# MANDATORY SERVICE BULLETIN

## NO. MSB-42-062/1

Replacement of the Landing Gear - Down Lock Pin

# WORK INSTRUCTION

**Replacement of the Circlips (Repetitive action every 200 hours)**

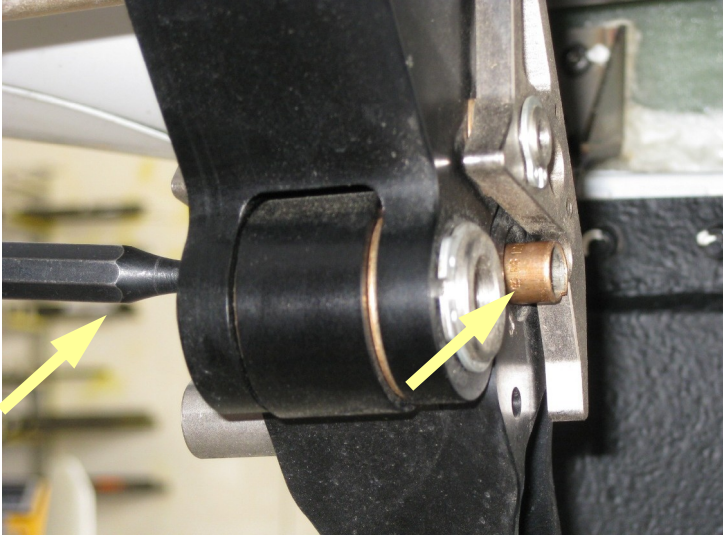
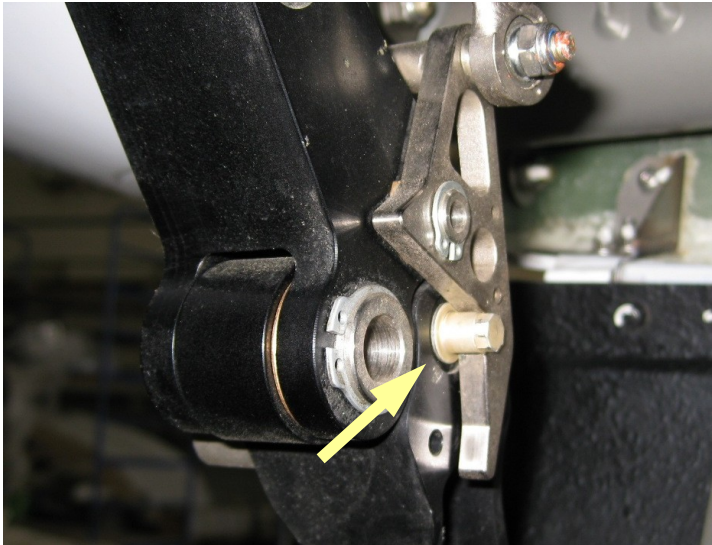
5	Remove the screw which connects the Hook Rod and the Hook Assembly and turn back the Hook Assembly. Discard the self locking nut.
6	Replace the two circlips which hold the bolt in position.  <b>CAUTION:</b> Do not overstress the circlip during the installation!
7	Turn the Hook Assembly into position and reinstall the screw connecting the Hook Assembly with the Hook Rod. Install the new self locking M6 - nut.
8	Clean working area and check for foreign objects.
9	Carry out step 5 – 8 on the Nose Landing Gear and the Main Landing Gear Assemblies.
10	Push the GEAR circuit-breaker and perform a retraction test.
